# Weir Phillips Heritage and Planning

**Re: DA/2020/0578, 2 Station Street, Marrickville  
Response to Council's Development Assessment Report for Sydney Eastern City Planning  
Panel, 10 June 2021**

[Image description: Plan of Basement 3 above shows the provision of Accessible parking space]

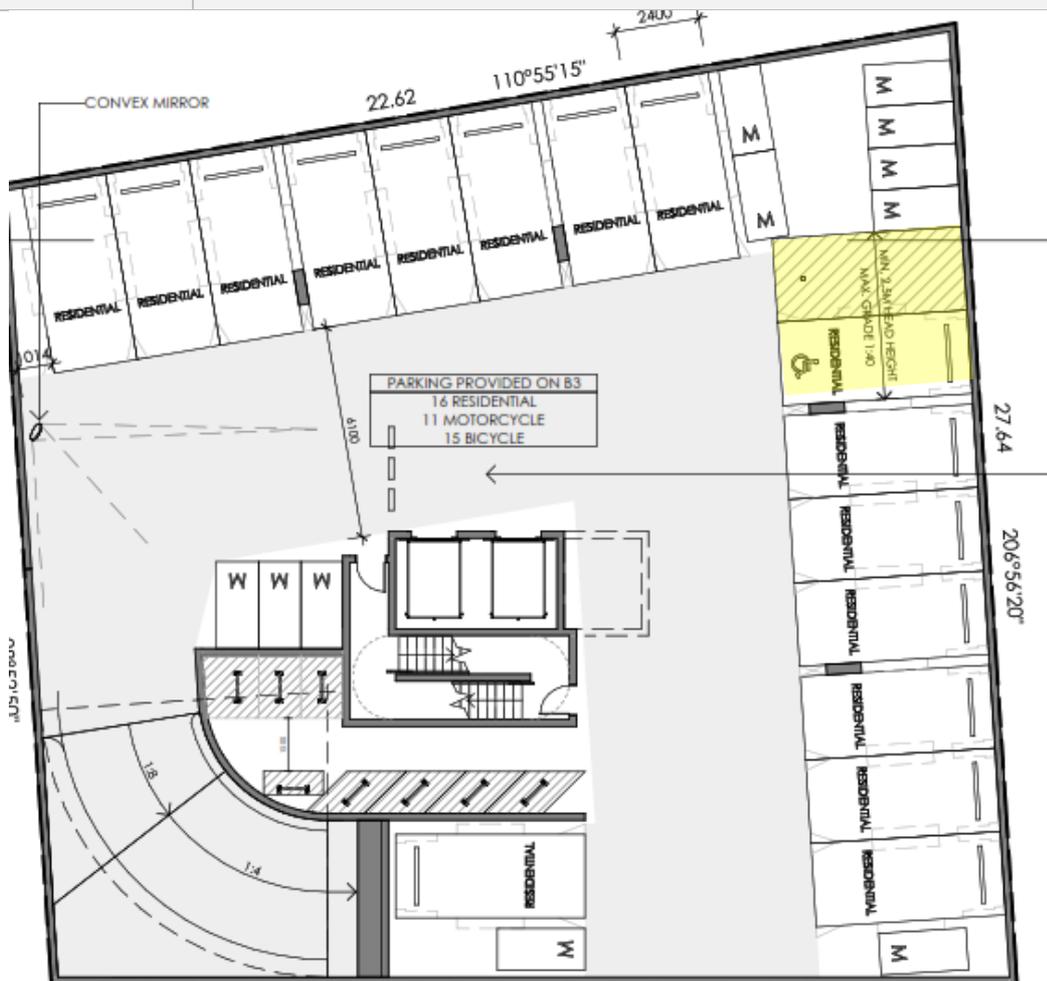
BCA Part D3.5 Accessible Carparking	
<b>Requirement</b>	<p><b>Class 3</b>            For Accessible parking requirements for boarding house, guest house, hostel etc.            Multiply total number of carparking spaces provided by the % of            - Accessible SOUs to the total number of SOUs or            - Accessible bedrooms to the total number of bedrooms            Calculated to the next whole number</p> <p>For Accessible parking requirements for residential part of school, accommodation for the aged, the disabled or children, residential part of health care building etc.            - 1 space per 100 carparking spaces</p>
<b>Compliance Comments</b>	<p>Complies.            Total number of carparking spaces provided = 45 allocated to the Residential component            Total number of accessible parking spaces required / provided as per the formula listed above in the requirements = 3            Detailed features of the accessible parking space to be verified at CC stage of works.</p>

<b>Requirement</b>	<p><b>Class 5</b>            - 1 Accessible car parking space per 100 carparking spaces</p> <p><b>Class 6</b>            - 1 Accessible car parking space per 50 carparking spaces (up to 1000 spaces) and additional 1 Accessible car parking space per additional 100 spaces provided</p>
<b>Compliance Comments</b>	<p>Complies.            Total number of Accessible parking spaces required / provided for the commercial component of the development = 1            Detailed features of the accessible parking space to be verified at CC stage of works.</p>
